# CONSERVATION COMMISSION AGENDA

Date: Thursday, Aug 17, 2023

#### 1. (7:00) 27 Cross St – Request for an Amended Order of Conditions – minor project revisions related to parking and building location – DEP #239-0939

#### 2. (7:20) 580 Walnut St – NOI – pool and accessories – DEP #239-0962

# 27 Cross Street -- Proposed Site Plan

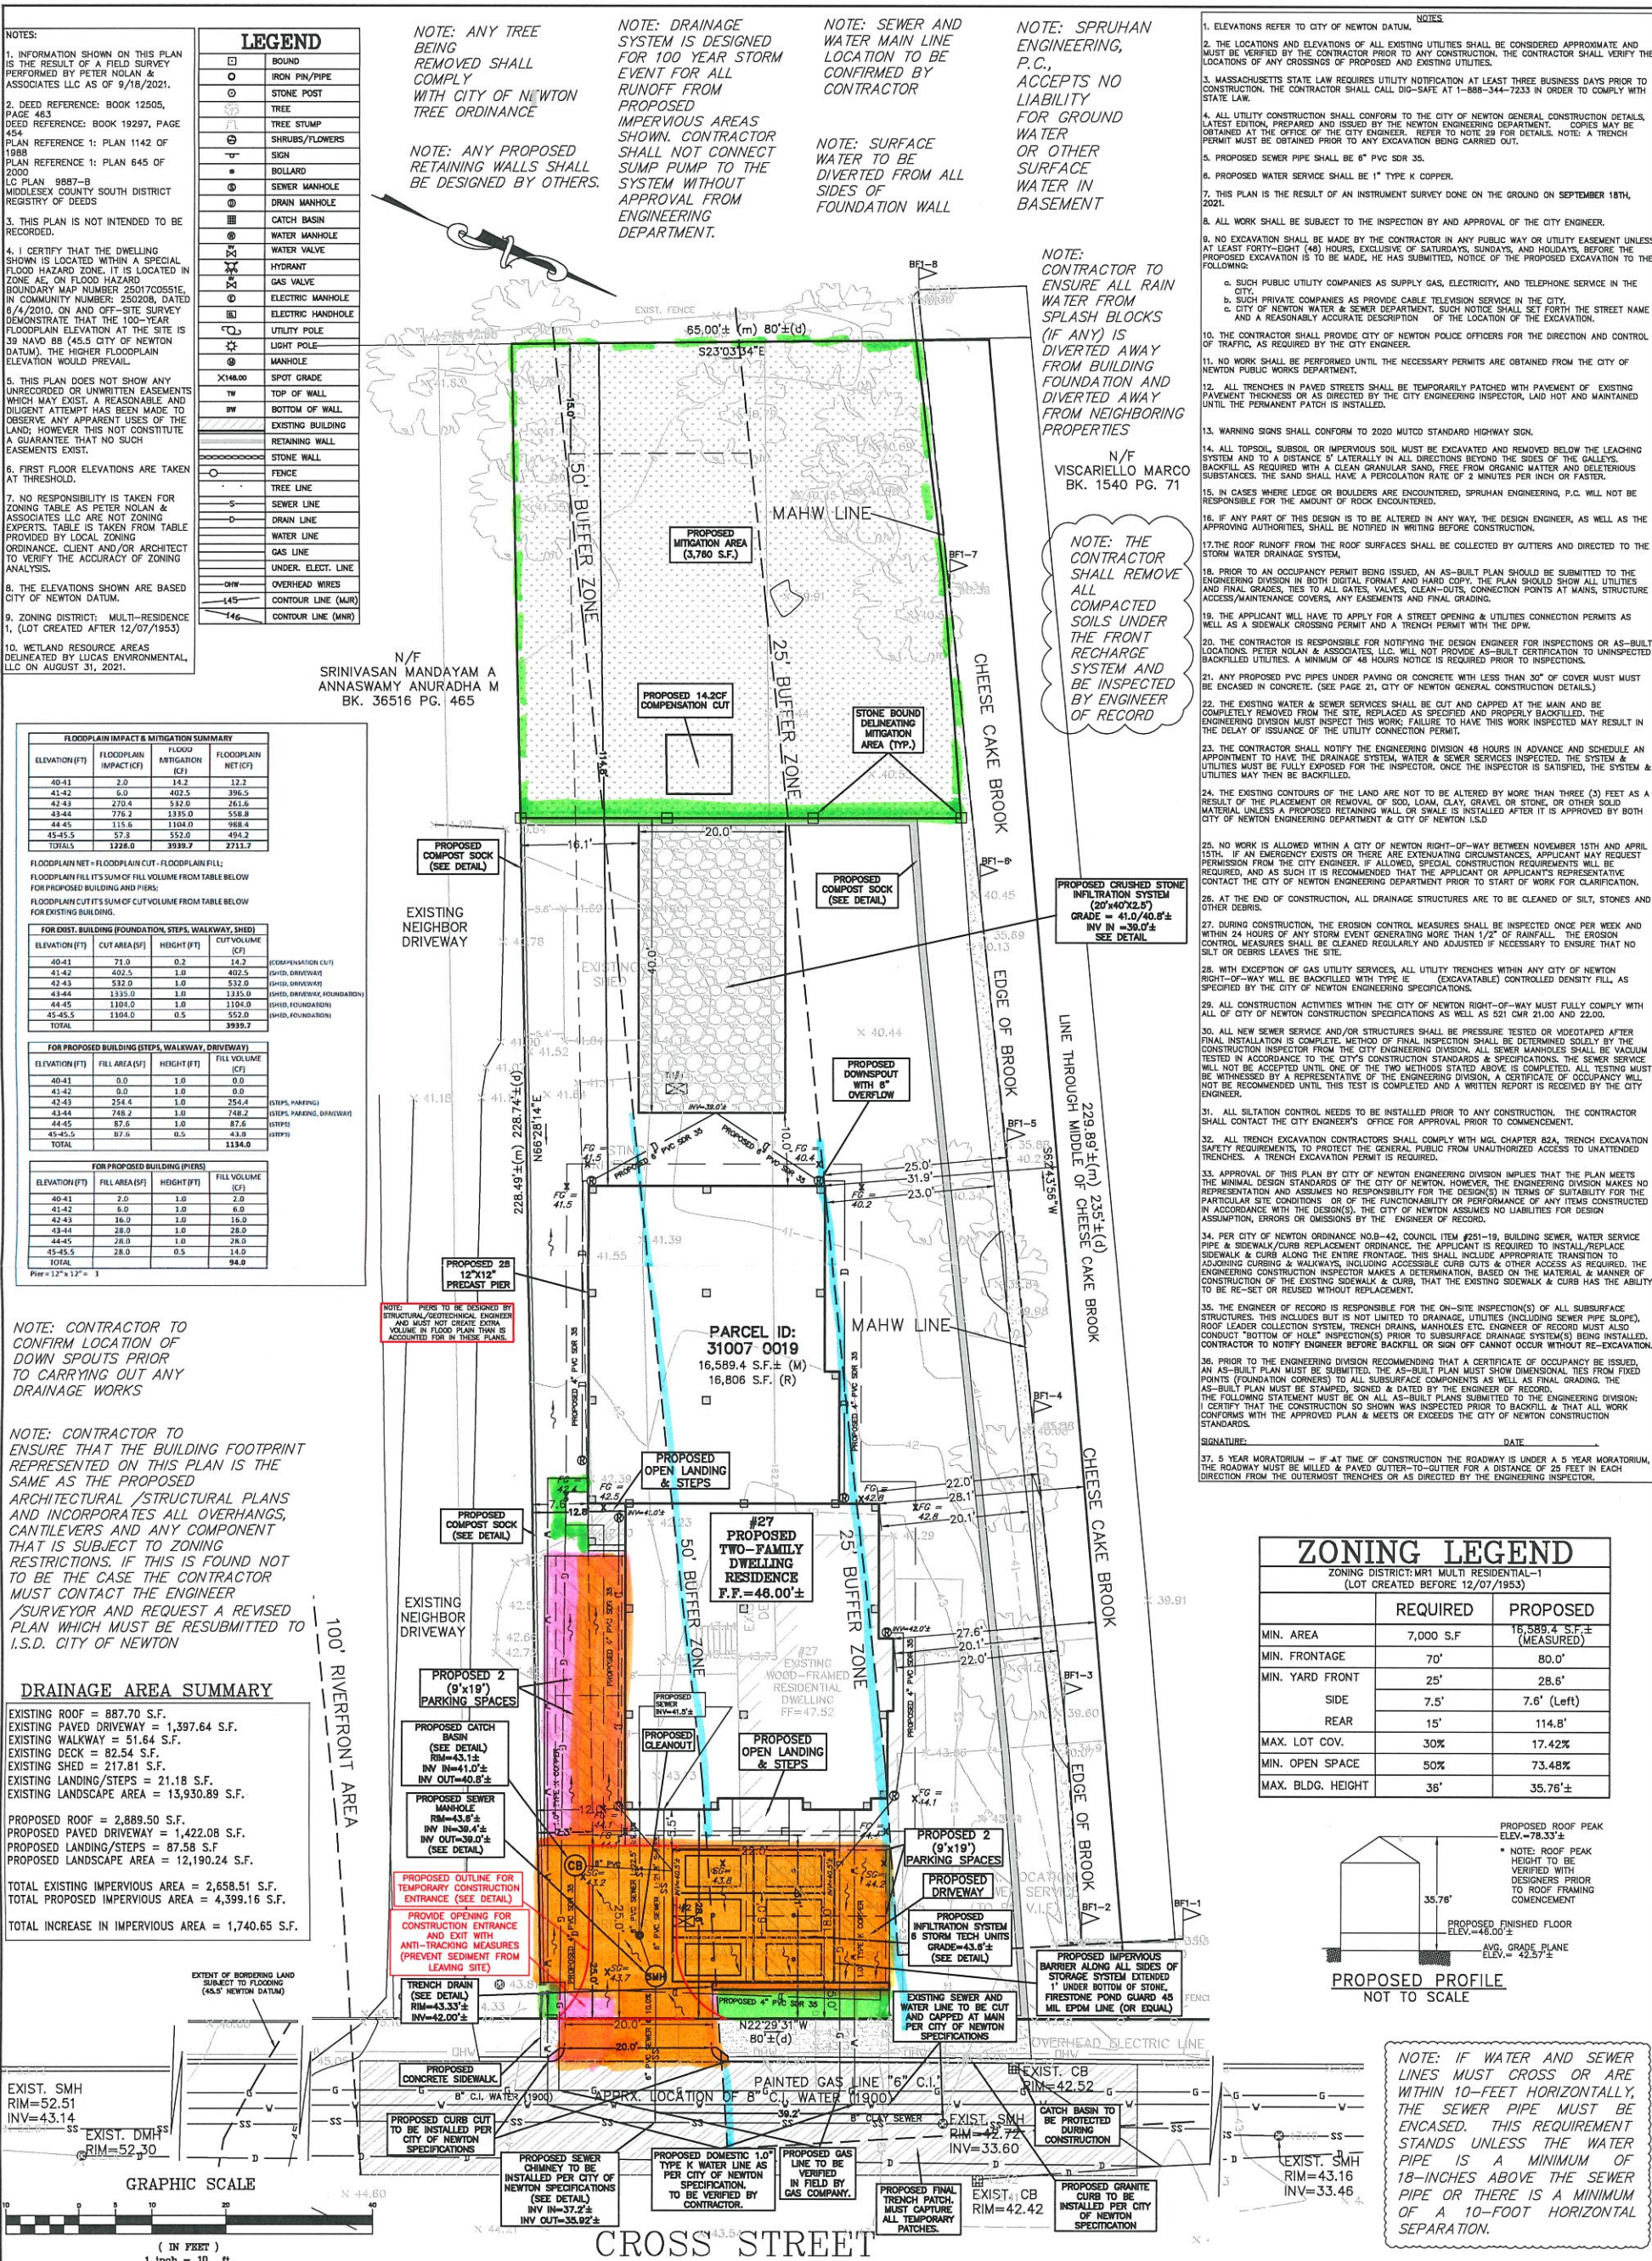
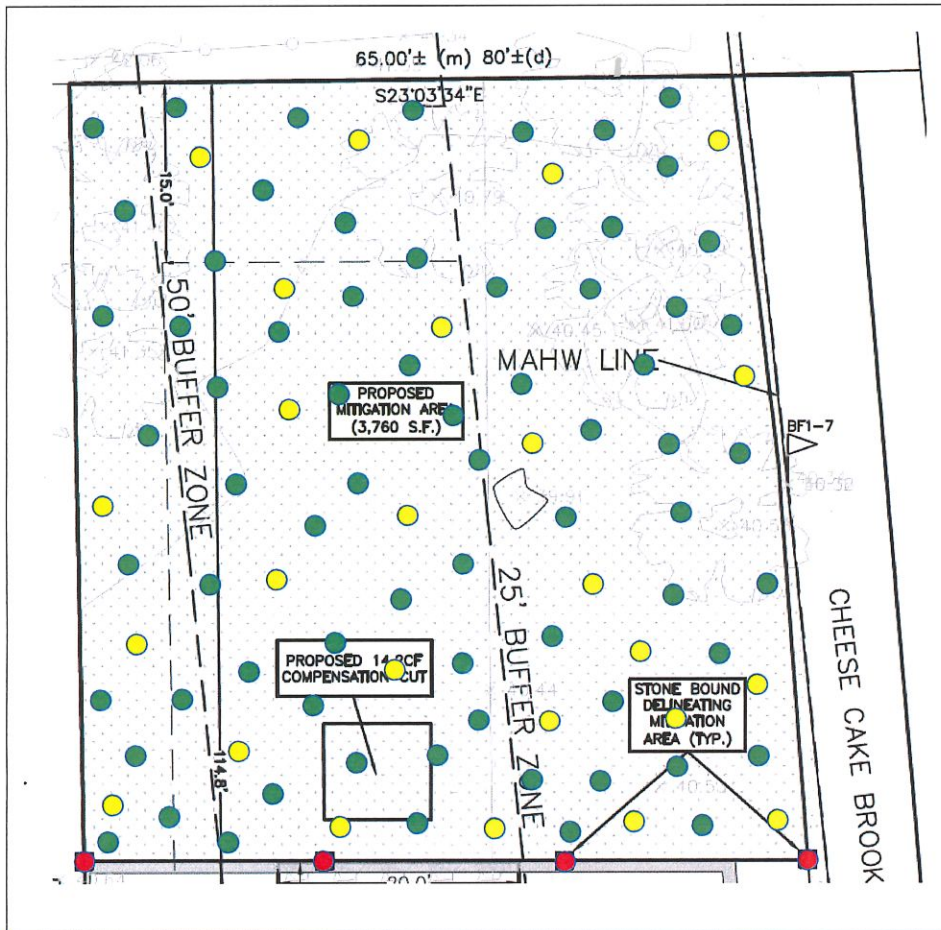
- ***Plan changes were made to comply with the zoning requirement to provide a total of 4 parking stalls.***
- ***The “side” walkway has been replaced by a 12-foot-wide driveway and the driveway opening has been widened.***
- ***The house has been shifted 3 feet closer to the stream (it is now due to be 28.1 ft at the closest point).***
- ***The new plans reduce the amount of new impervious area by 22 sf.***
- ***The new plans reduce flood storage capacity by 329 cf.***
- ***The new plans expand the mitigation planting area by 160 sf and add one deciduous sapling.***

# 580 Walnut Street Proposed Site Conditions

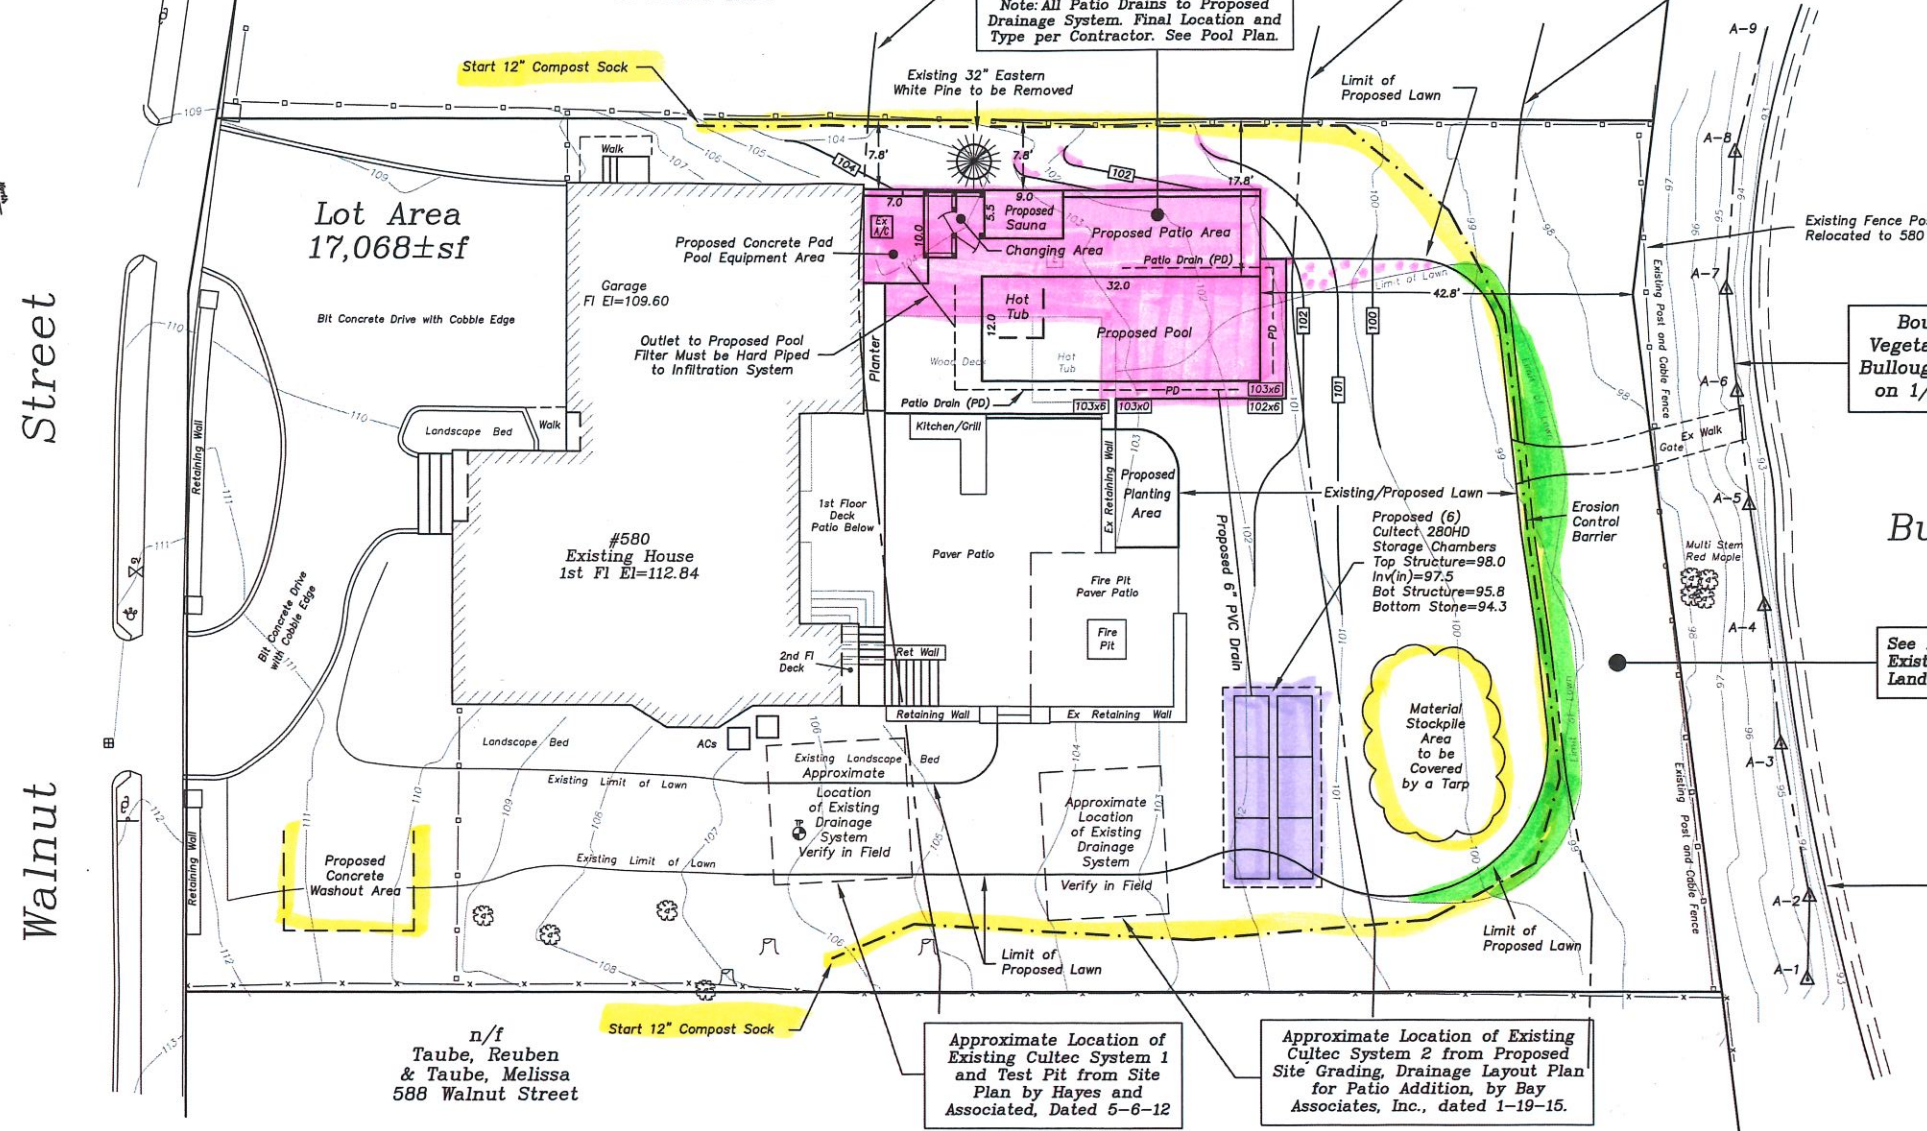
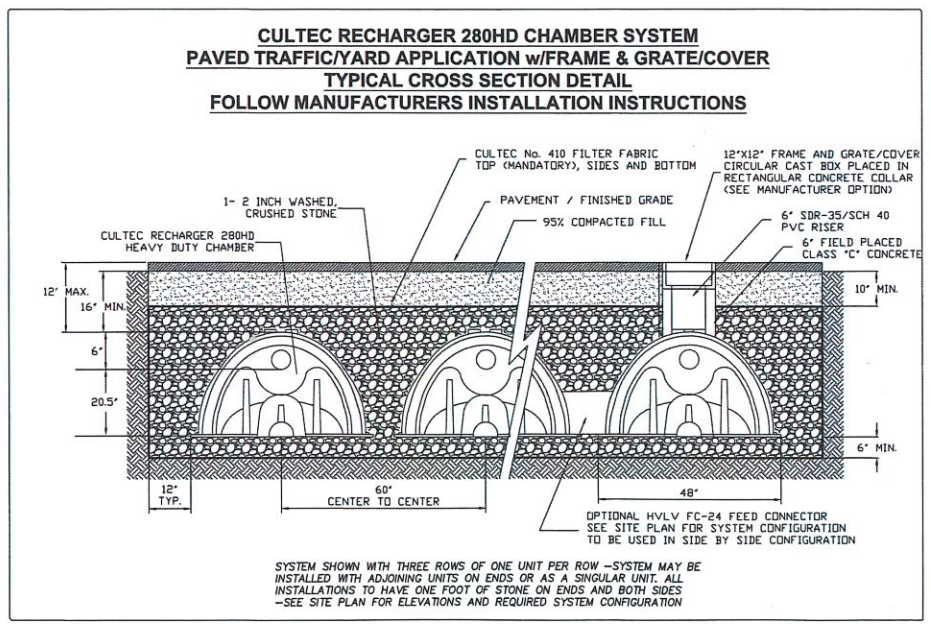
- Staff feel that 12" compost sock and the stockpile area shown on the plan may not be sufficient given the anticipated scale of excavation for the infiltration system and the pool.

- The concrete washout should be shown as 4-sided on the plans.
  - On southern property line there are 3 large burning bush (winged Euonymus). Two are proposed to be removed; the third should also be removed.
